**Planning Application for
Minor Relaxation of Building Height Restriction to Construct a Car Park and an
Ancillary Plant Room at Basement Level for Permitted Residential Development
at No. 3 Lincoln Road,
Kowloon Tong, Kowloon
(New Kowloon Inland Lot No. 713)
(Planning Application No. A/K18/350)**

We submit herewith a set of replacement pages of the Application Form and "Response-to-Comments" in responding to the government departmental comment for the captioned planning application.

Response-to-Comments

Alternative Scheme (without Basement)

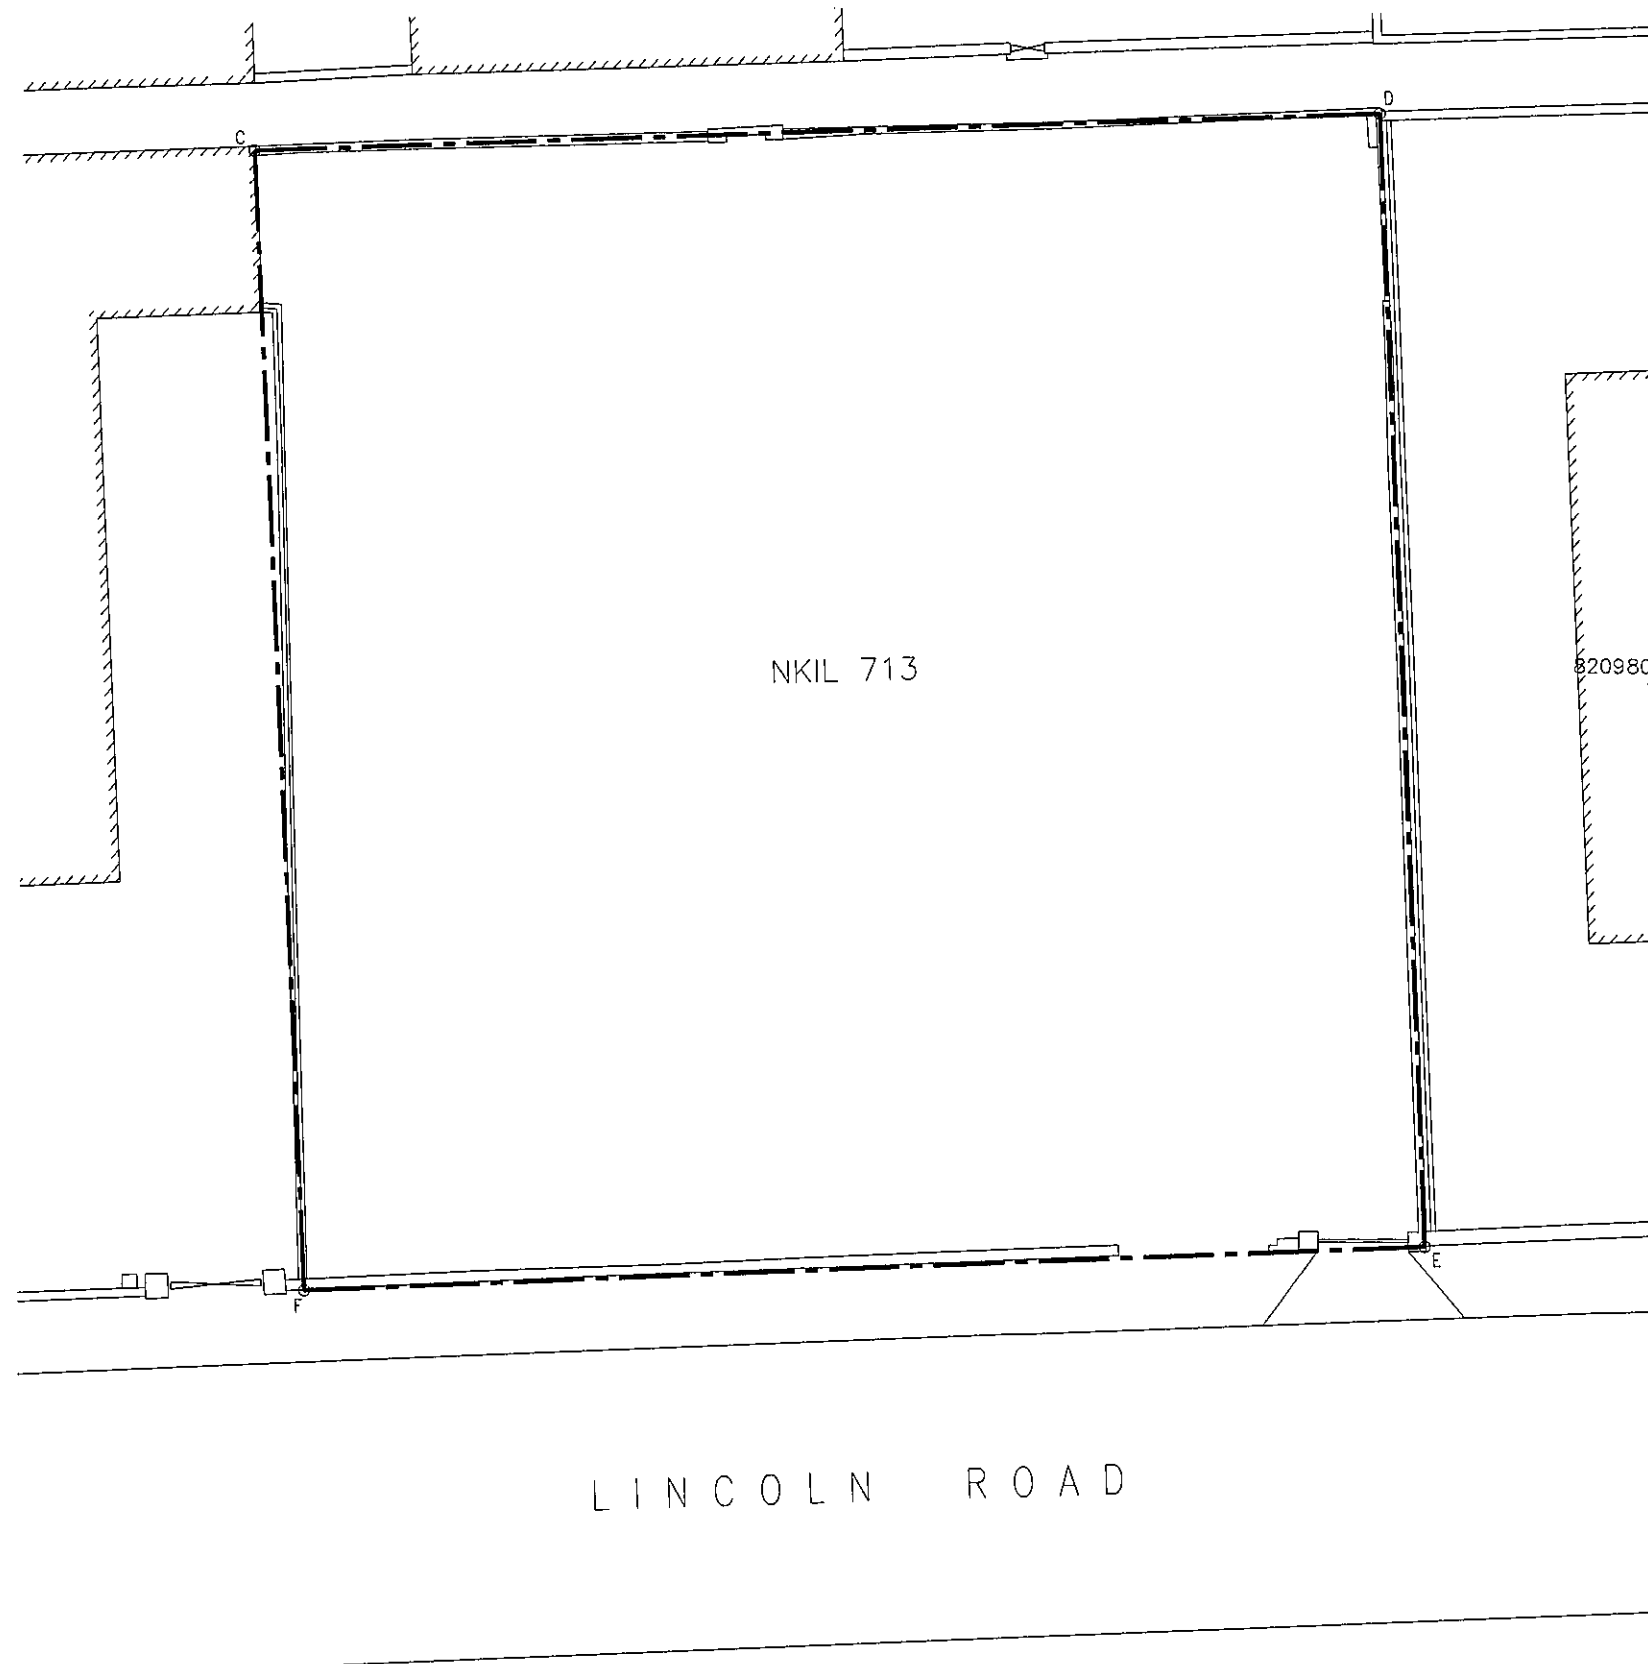
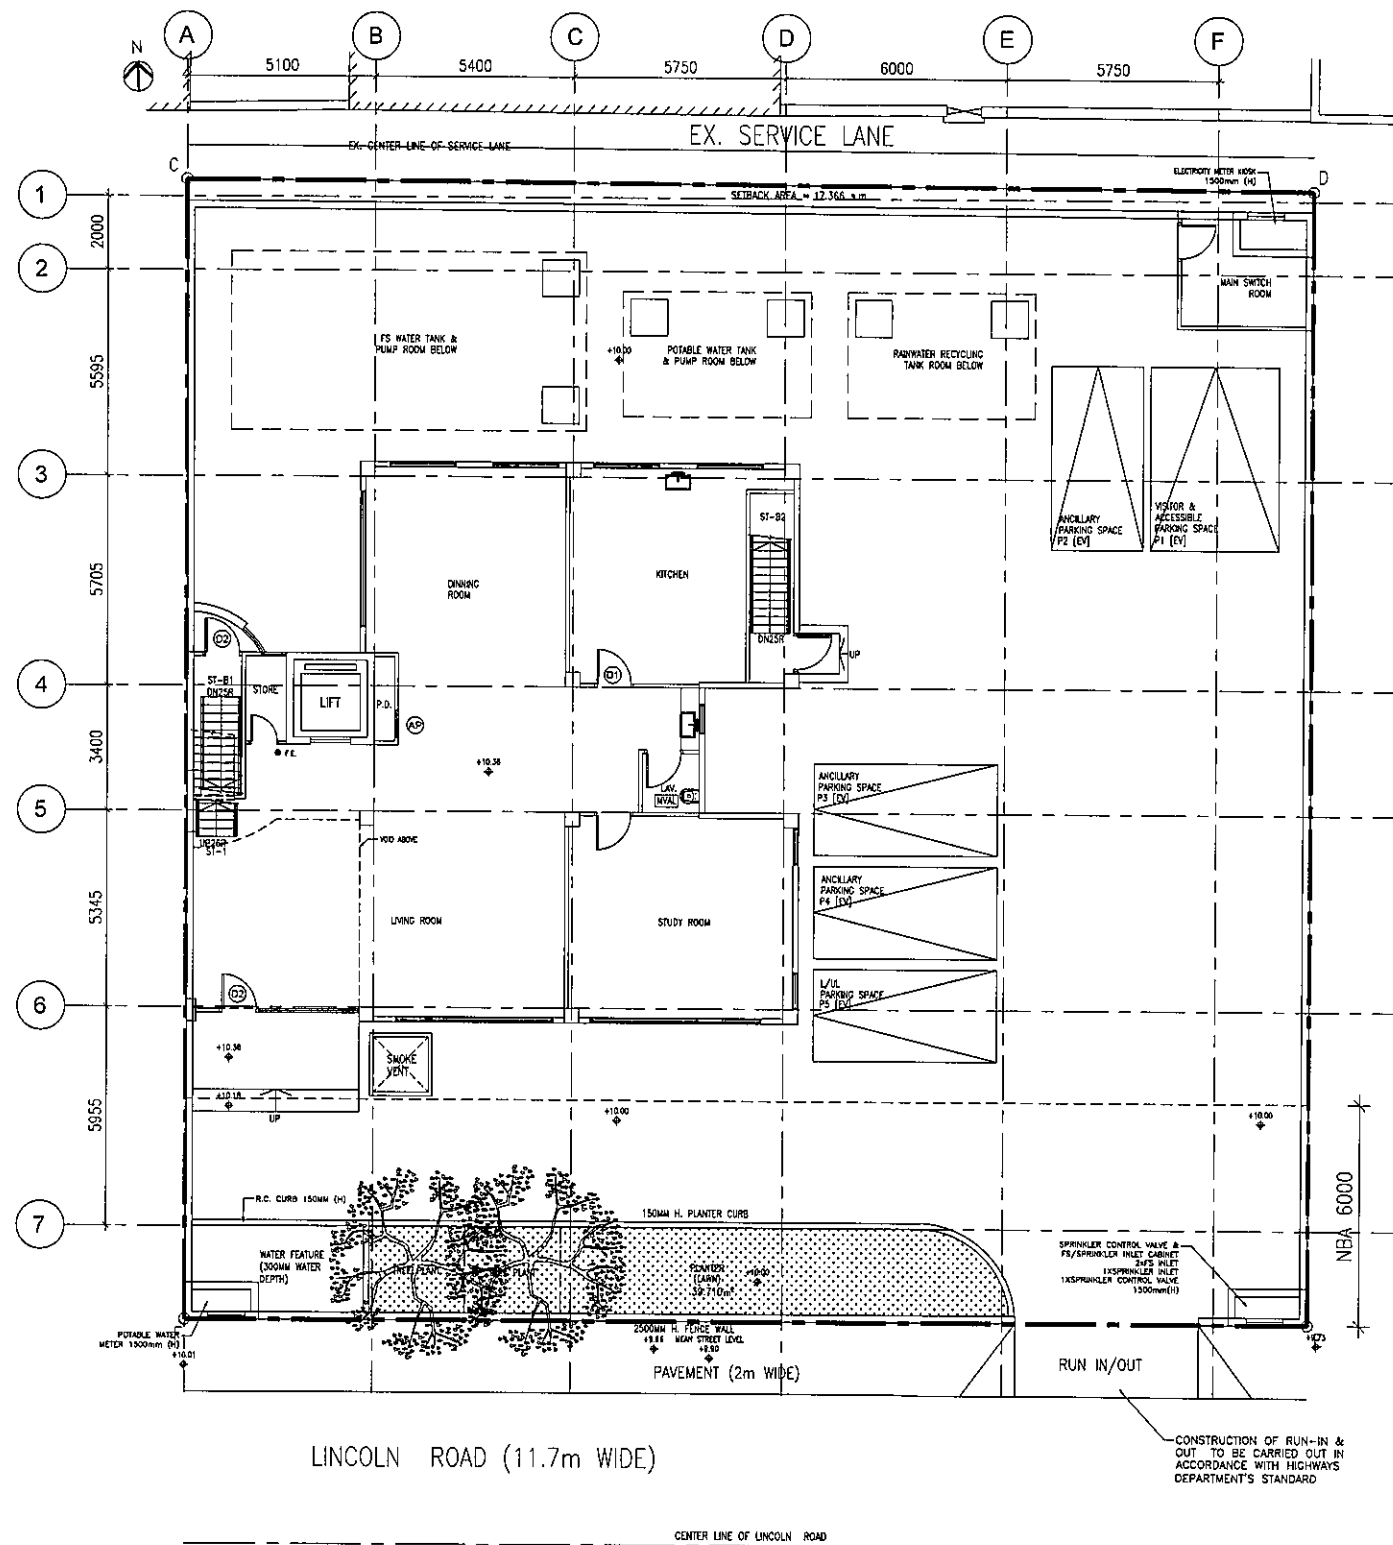
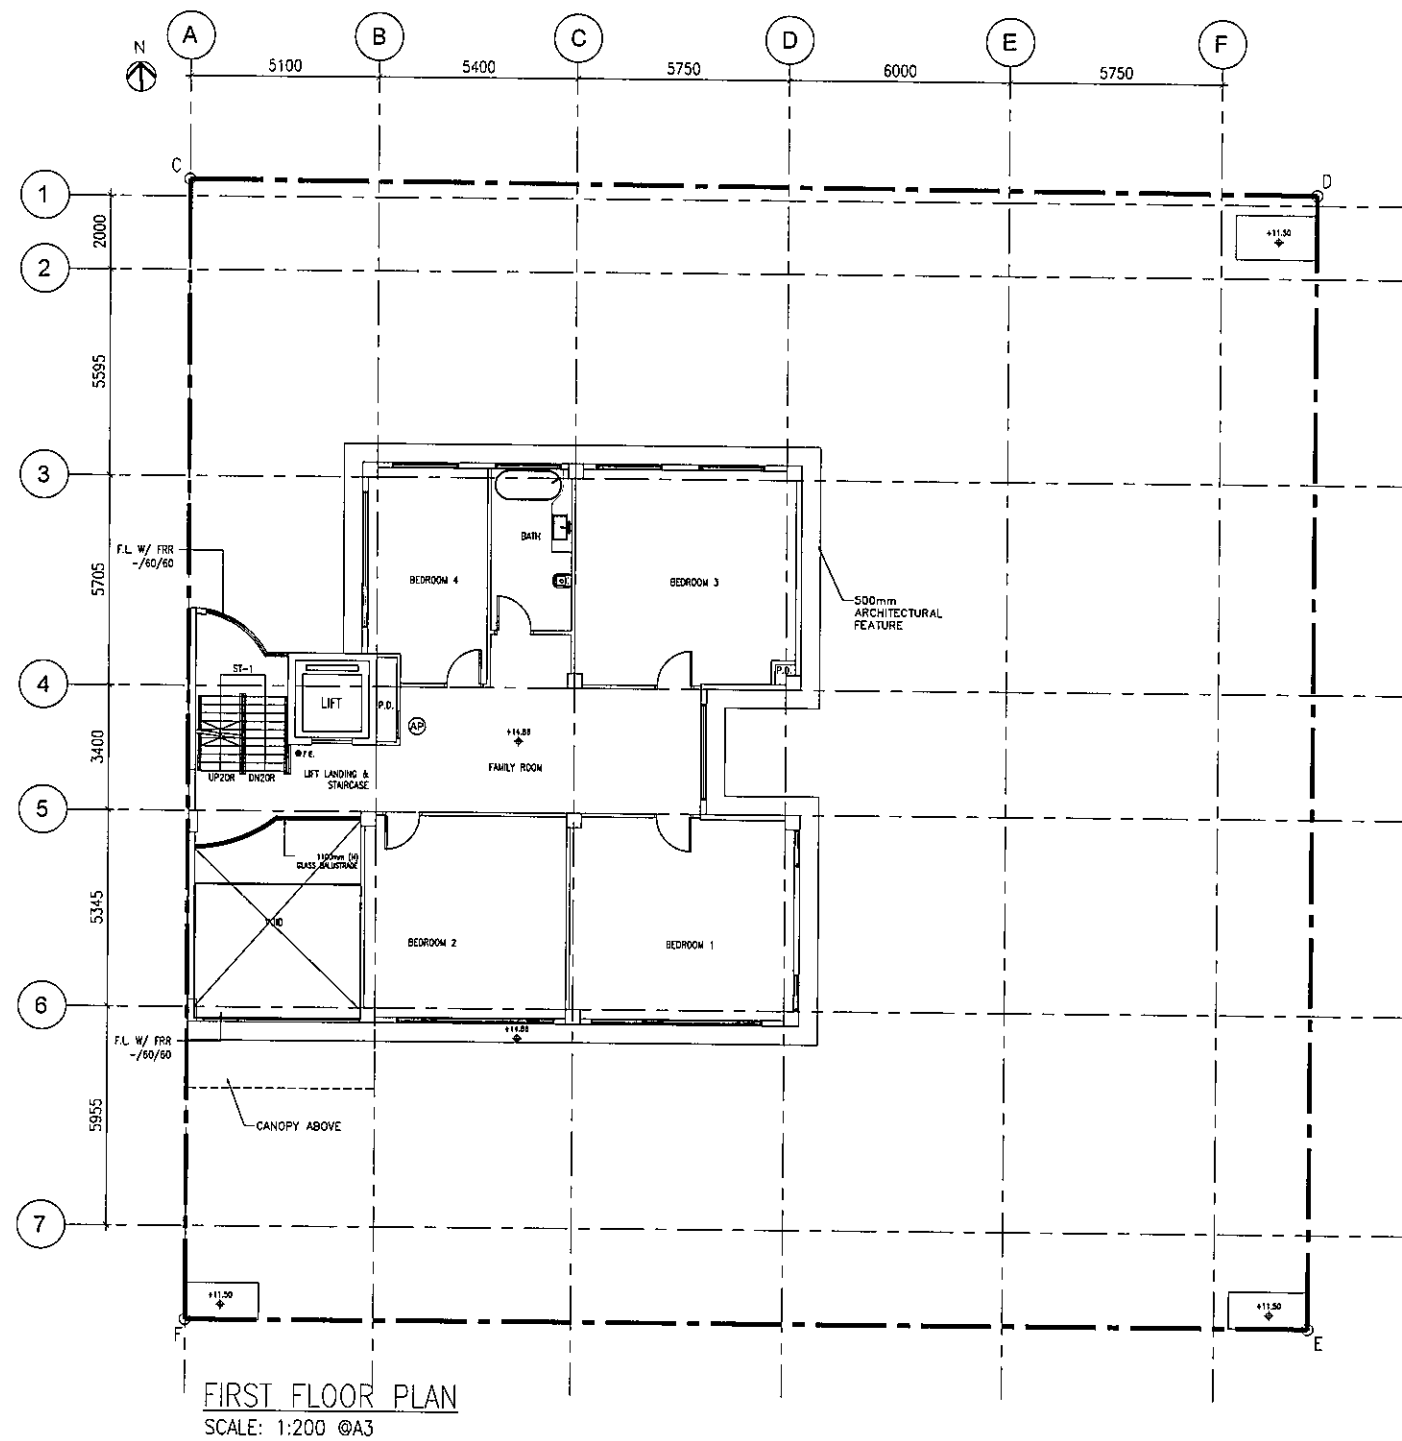
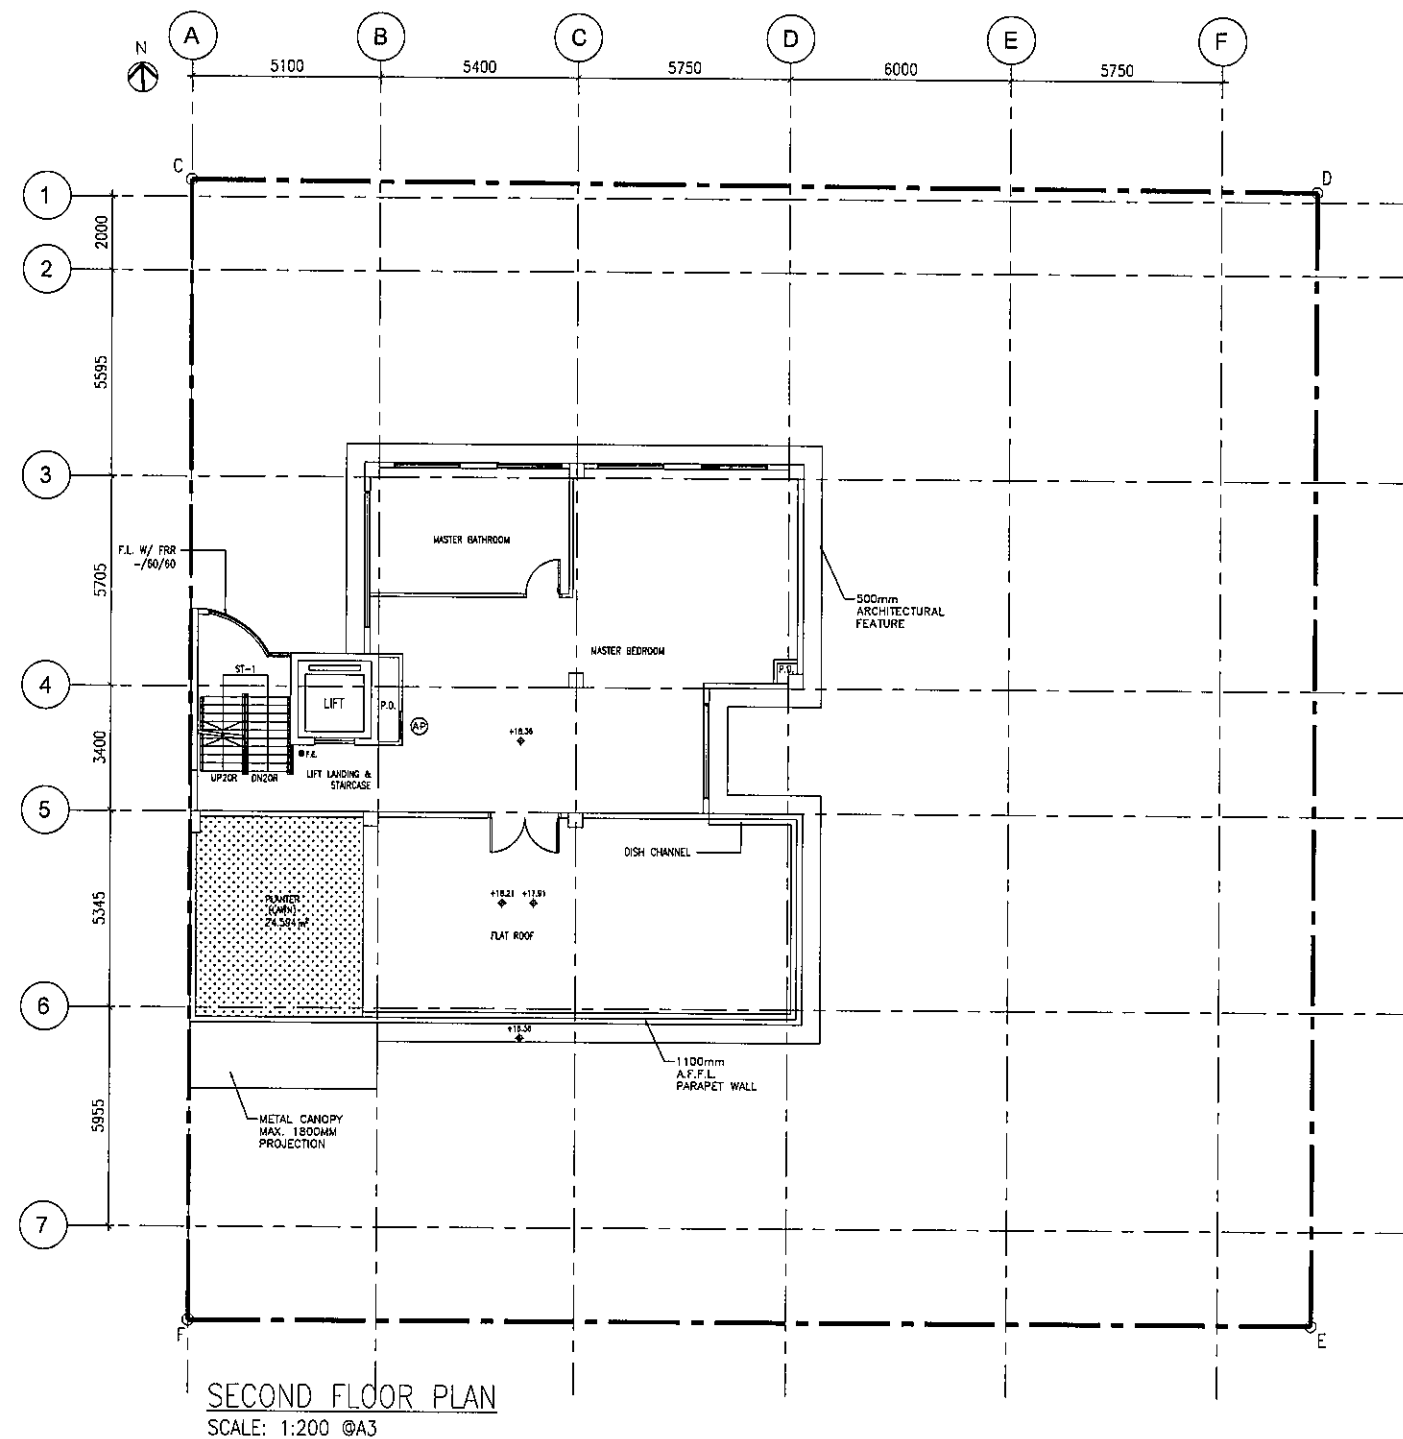
for our assessment.	
4.	<p>It is noted from paragraph 6.4 of planning statement that “Placing the proposed car parking spaces and ancillary plant rooms at the basement level can reduce the building bulk and provide more open spaces at ground level for gardening and landscaping purposes, which would definitely improve air ventilation and amenity in the area”. Please elaborate how the proposed relaxation of BHR can improve air ventilation and amenity in the area. Please also provide an alternative scheme (with car parks and plant rooms NOT in the basement) to justify the necessity of the proposed basement.</p>	<p>The proposed minor relaxation of BHR can improve air ventilation and amenity in the area due to the followings:</p> <ul style="list-style-type: none"> (a) Building bulk is minimized as far as possible by placing the ancillary plant rooms and car parking spaces at the basement, and allowing the provision of a larger greenery / landscaping area. (b) Set back of 6m from Lincoln Road in accordance with the non-building area (NBA) requirement for streetscape enhancement as stipulated under the Kowloon Tong Outline Development Plan (ODP). (c) Stepped terraced design by setting back 2/F with landscaped flat roof are provided to break down the visual bulk of the proposed development as viewed from pedestrian level, and to allow the provision of curvilinear planter connecting the different floors, which soften the building mass and also enhance the amenity of the development as well as the neighbourhood. (d) Landscaping is proposed at grade with combination of trees, shrubs and ground cover within the site, which will be visible to the public to enhance the amenity of the public realm. <p>Please see the Alternative Scheme (without basement) at Appendix 2 for showing the difference below:</p>

<p>(a) The landscape area would reduce from 193.461m² to 64.304m².</p> <p>(b) The ancillary plant rooms would have to be provided at roof level and there would be more bulky building design.</p> <p>(c) The car parking spaces and loading/unloading (L/UL) bay for meeting the requirements from the Commissioner for Transport (C for T) and the required maneuvering areas would have to be located at-grade and would occupy major portion of the open area.</p> <p>Nevertheless, the proposed basement area is reduced from 715m² to 689.165m² for minimizing the basement size. The revised proposed basement area is devised based on the functional, building services, geotechnical and structural design requirements of the house.:-</p>
